SUBJECT: R.E. GINNA NUCLEAR POWER PLANT – CORRECTION TO AMENDMENT
NO. 116 ISSUED AUGUST 12, 2014, RE: REVISION TO TECHNICAL
SPECIFICATION SECTION 3.6.5, "CONTAINMENT AIR TEMPERATURE."
(TAC NO. MF0900)

SUBJECT: R.E. GINNA NUCLEAR POWER PLANT - ISSUANCE OF AMENDMENT RE:
REVISION TO TECHNICAL SPECIFICATION SECTION 3.6.5, "CONTAINMENT
AIR TEMPERATURE." (TAC NO. MF0900)

Amendment No. 116
Renewed License No. DPR-18

SAFETY EVALUATION BY THE OFFICE OF NUCLEAR REACTOR REGULATION

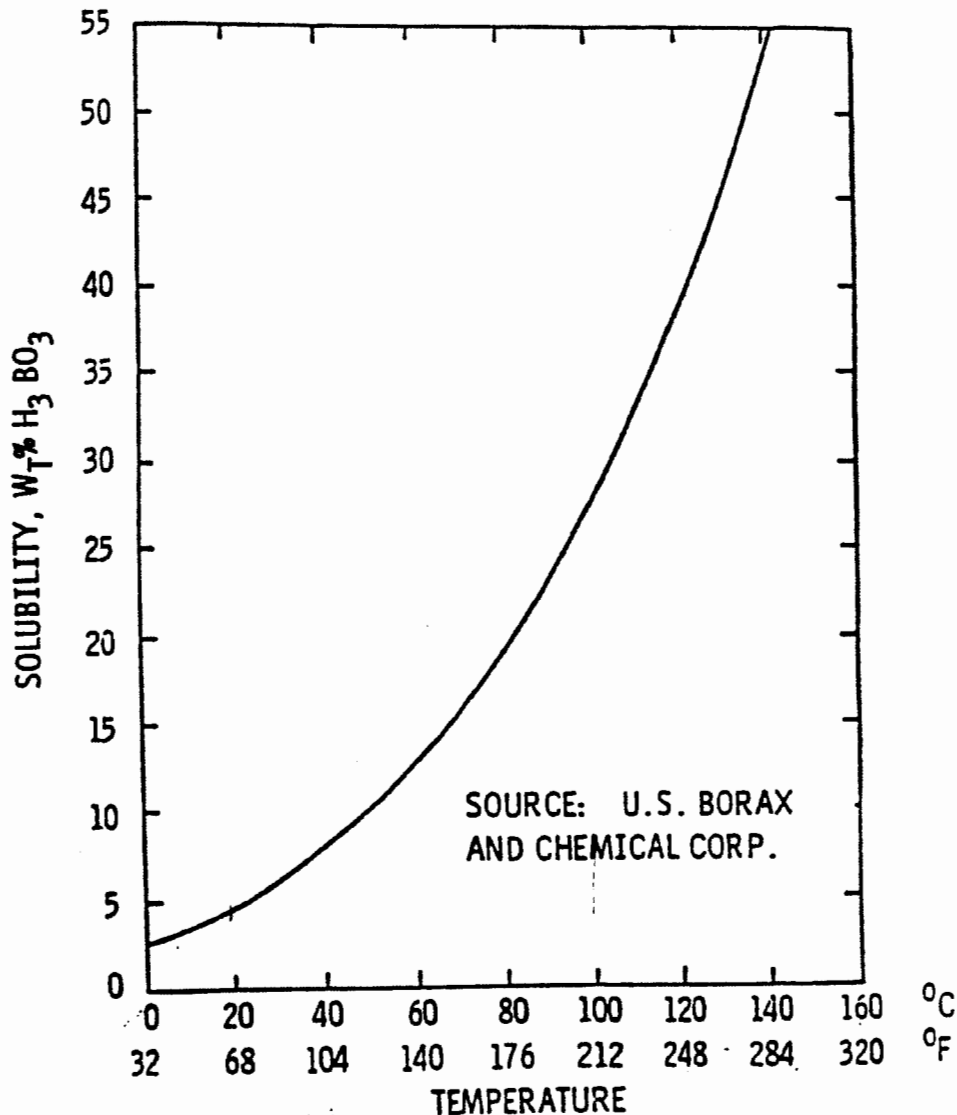
For break sizes 4-inches and larger, accumulator injection is required to prevent the core from becoming uncovered. In these cases, the accumulator flow rate is the dominating factor in the analyses. The amount of water entering the RCS to fill the downcomer and core and mixing with the cold leg fluid that is much hotter outweighs the 5 °F increase in accumulator temperature. This leaves the 2-inch break size as the limiting case.

For the 3-inch break size where accumulator injection occurs only 75 seconds before PCT, core recovery depends on the timing of accumulator injection. If the accumulator temperature increases, fuel temperatures increase for a longer period of time once SI injection occurs. This will ultimately cause PCT to increase. The PCT for a break size of 3 inches is 1117 °F. There is a 50 °F margin between this case and the limiting PCT of 1167 °F for the 2-inch break. The result of a 5 °F increase in accumulator temperature will have a negligible impact on PCT when compared to the 50 °F margin to the limiting PCT for this case. This is because, similar to break sizes of 4-inches and larger, the amount of mass entering the system and mixing with the cold leg fluid that is much hotter outweighs a 5 °F increase in accumulator temperature.

The licensee concludes that the PCT for an SBLOCA remains 1167 °F for a break size of 2 inches. Based on the above discussion, the NRC staff finds the results of the licensee's analysis acceptable.
